SERVICE INFORMATION BULLETIN

TITLE : Electronic/Hydraulic Power Assisted Pump (EHPAS) noise

DOCUMENT # : 11 D 001

AFFECTED VEHICLES : 12C's built from start of production until 30.05.2012

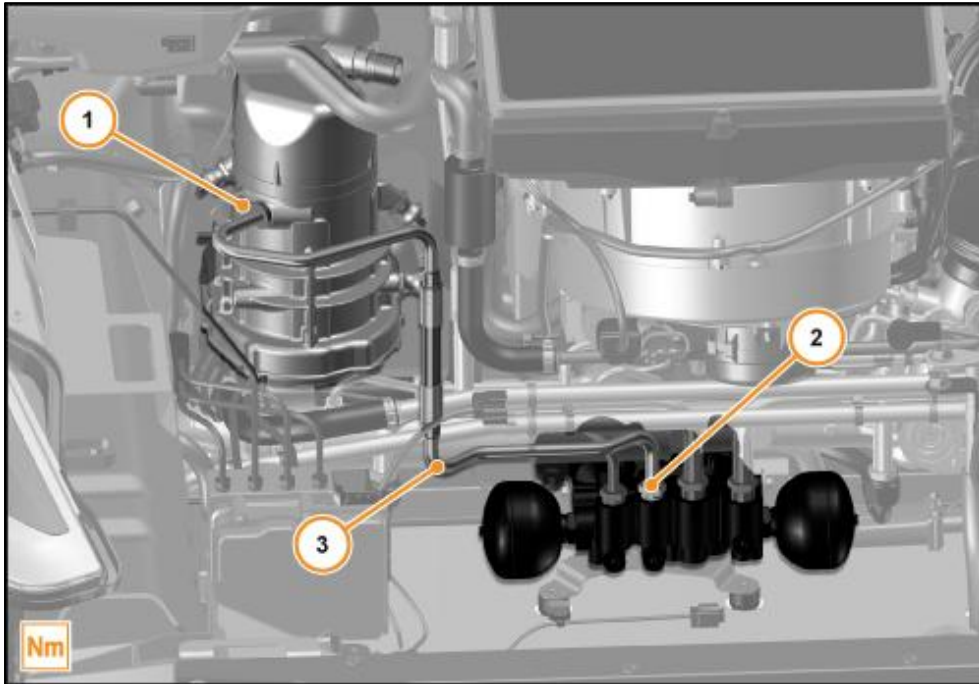
3. Remove bolt (1). M8x20 25Nm.
4. Detach (2) and remove pipe (3) from steering pump to APMU. M16x1.5 40Nm.

5. Replace the existing EHPAS pump feed pipe to APMU with part number 11D0149CP(LHD) or 11D0150CP(RHD).
6. Fill/bleed the suspension hydraulic system by following the instruction A-RM-03B01-01-002 - Fill/bleed fluid – suspension system.
7. Install components in reverse order.
8. Check functionality of the system.
